World Forum for Harmonization of Vehicle Regulations

Proposal for Supplement 4 to the 01 series of amendments to Regulation No. 94 (Frontal collision protection)

Submitted by the Working Party on Passive Safety *

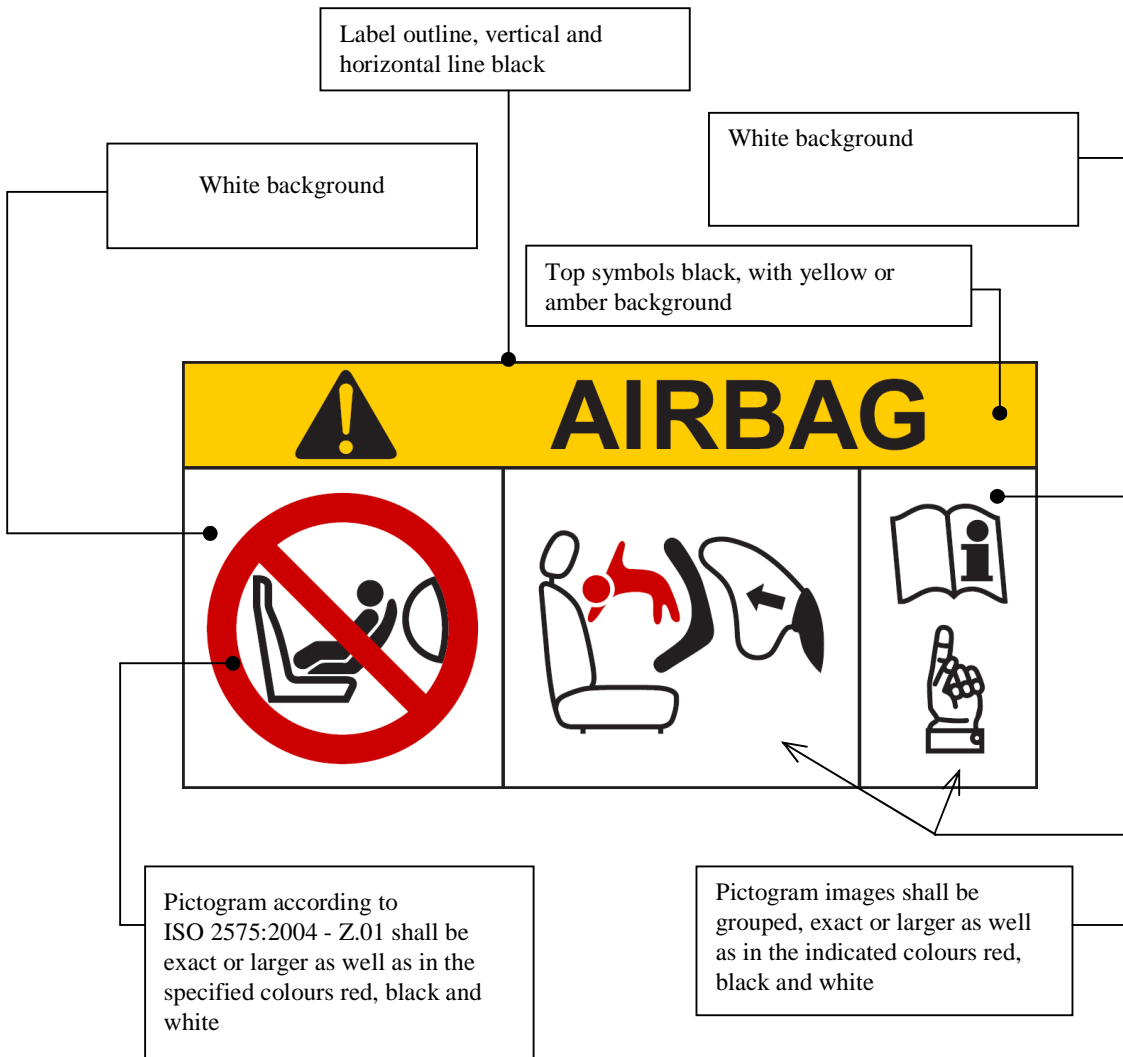
Paragraph 6.2.1., amend to read:

"6.2.1. As a minimum, this information shall consist of a label containing clear warning pictograms as indicated below:

The overall dimensions shall be at least 120 x 60 mm or the equivalent area.

The label shown above may be adapted in such a way that the layout differs from the example above; however, the content shall meet the above prescriptions."
